City of Detroit
Inter-Departmental Communication

RE: Petition No. 476
Requested Encroachment in front of 6533 East Jefferson with Fencing between
Bellevue St. and Beaufait St.

**REQUEST ENCROACHMENT
 INTO JEFFERSON AVE. E.
 AT 6533 JEFFERSON AVE. E.
 (With Fencing)**

PROVISIONS FOR ENCROACHMENT For Petition 476

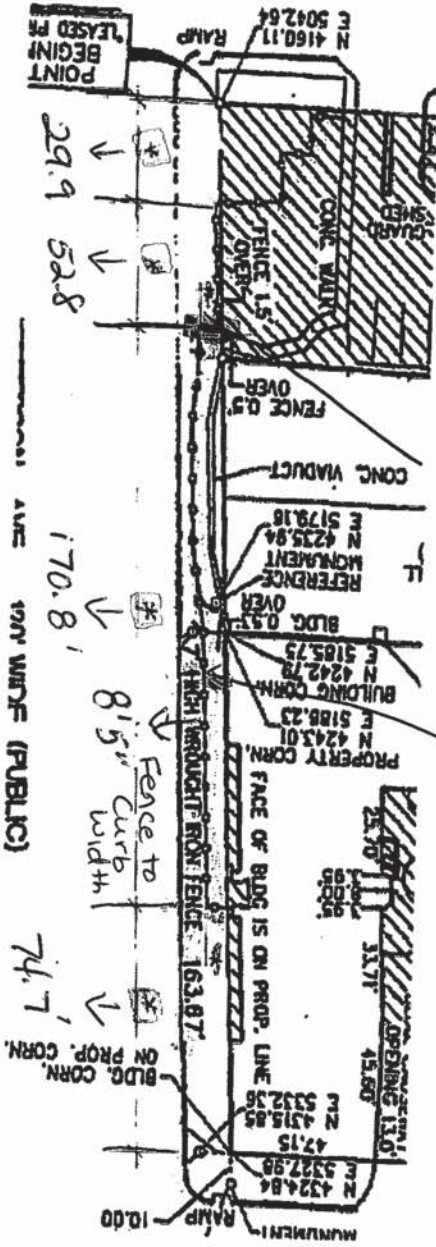
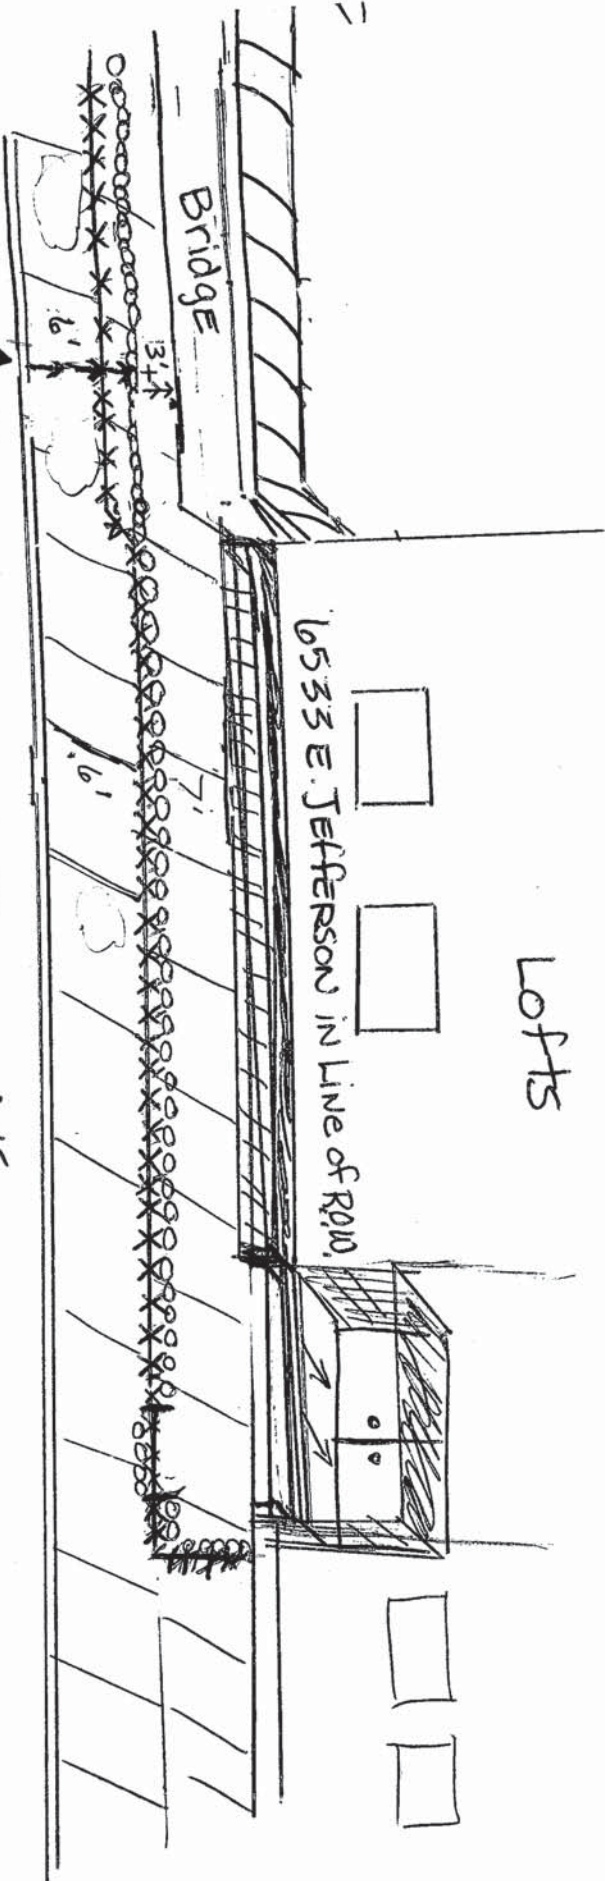
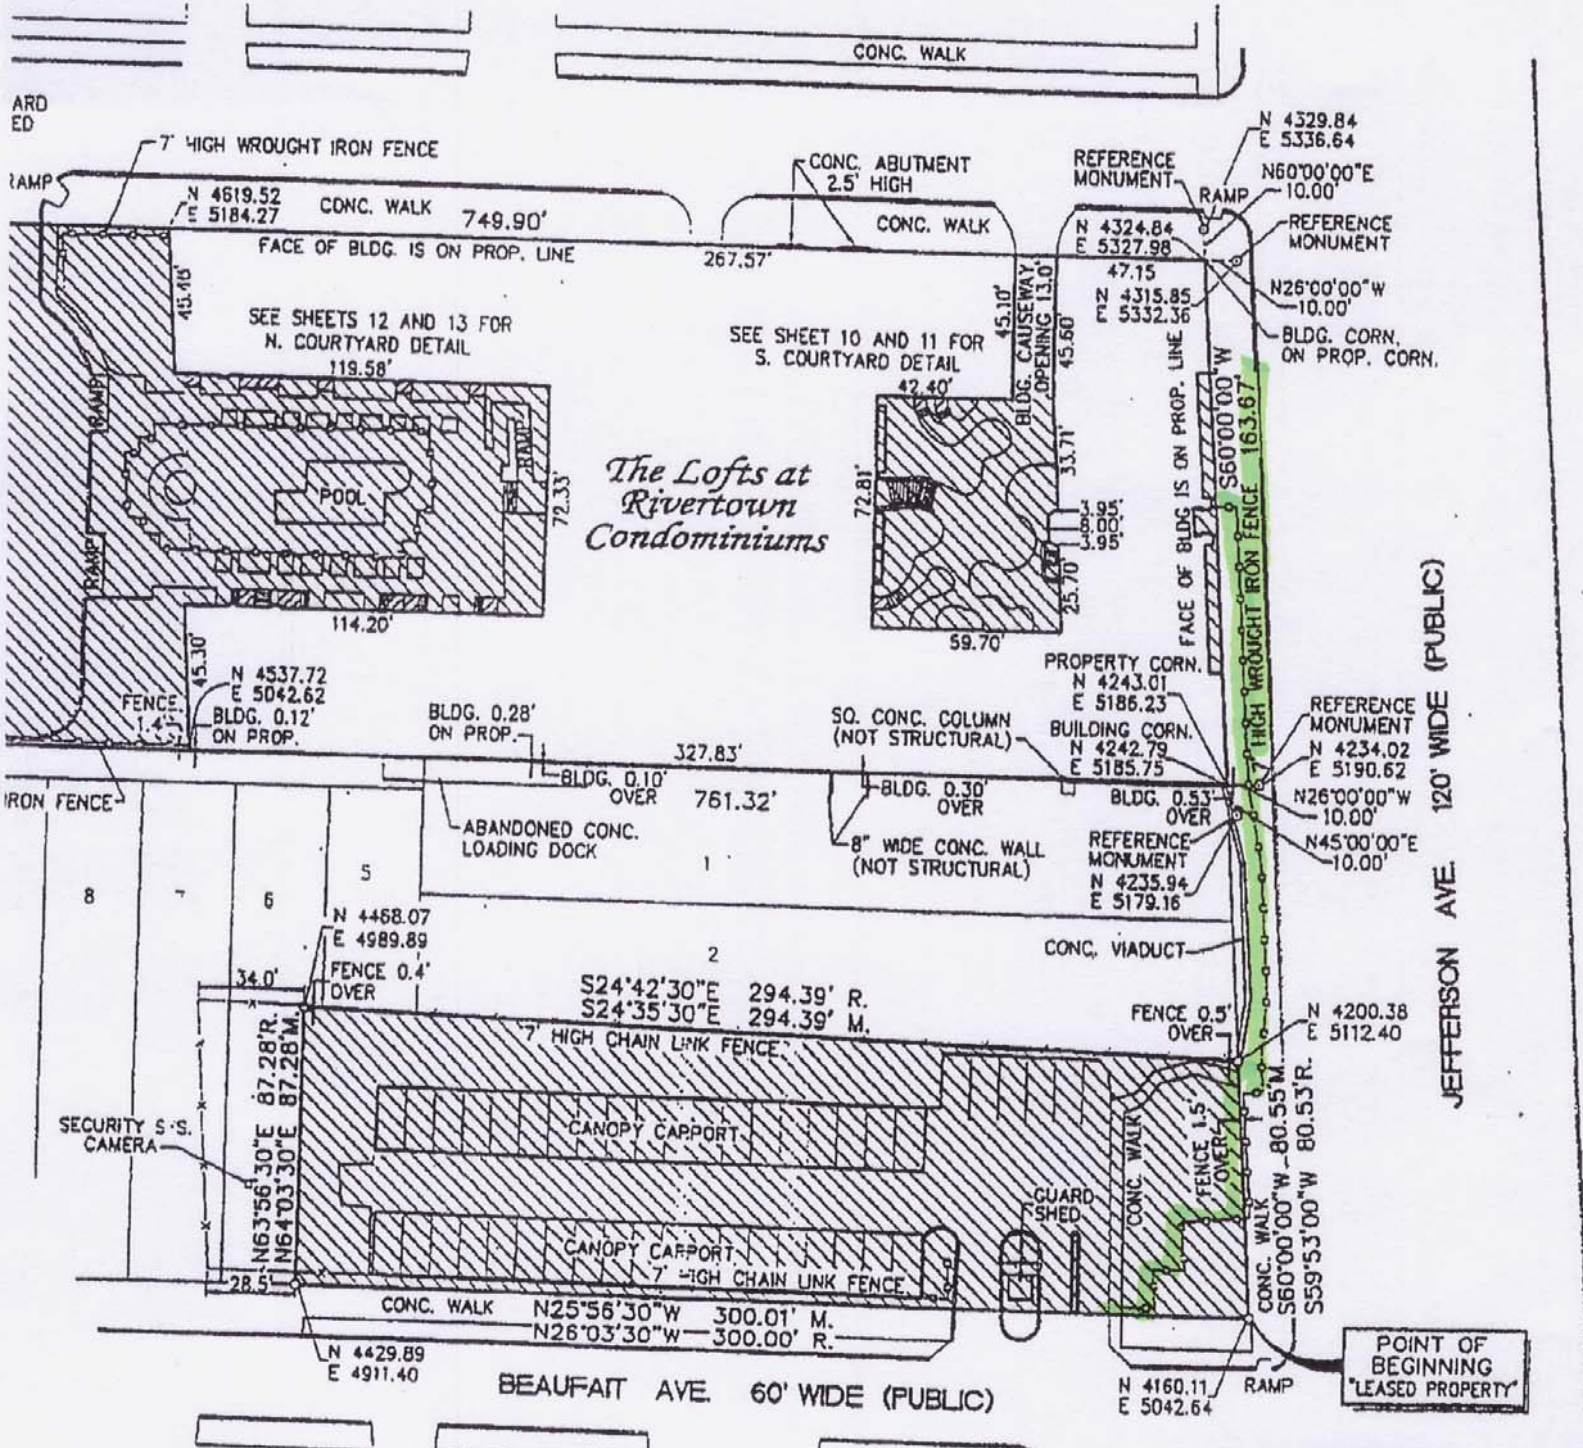
- Our records indicate that there are water mains and sewers in the areas of encroachments. DWSD has no objections to the requested encroachments provided that the attached Provision for Encroachment is strictly followed.

1. By approval of this petition the (DWSD) does not waive any of its rights to its facilities located in the right of way, and at all time, DWSD, its agents or employees, shall have the right to enter upon the right of way to maintain, repair, alter, service, inspect, or install its facilities. All costs incident to the damaging, dismantling, demolishing, removal and replacement of structures or other improvements herein permitted and incurred in gaining access to DWSD's facilities for maintenance, repairing, alteration, servicing or inspection caused by the encroachment shall be borne by the petitioner. All costs associated with gaining access to DWSD's facilities, which could normally be expected had the petitioner not encroached into the right of way shall be borne by DWSD.

2. All construction performed under this petition shall not be commenced until after five (5) days written notice to DWSD. Seventy-two (72) hours notice shall also be provided in accordance with P.A. 53 1974, as amended, utilizing the MISS DIG one call system.

3. Construction under this petition is subject to inspection and approval by DWSD forces. The cost of such inspection shall, at the discretion of DWSD, be borne by the petitioner.

4. If DWSD facilities located within the right of way shall break or be damaged as the result of any action on the part of the petitioner, then in such event the petitioner agrees to be liable for all costs incident to the repair, replacement or relocation of such broken or damaged DWSD facilities.

5. The petitioner shall hold DWSD harmless for any damage to the encroaching device constructed or installed under this petition, which may be caused by the failure of DWSD's facilities.
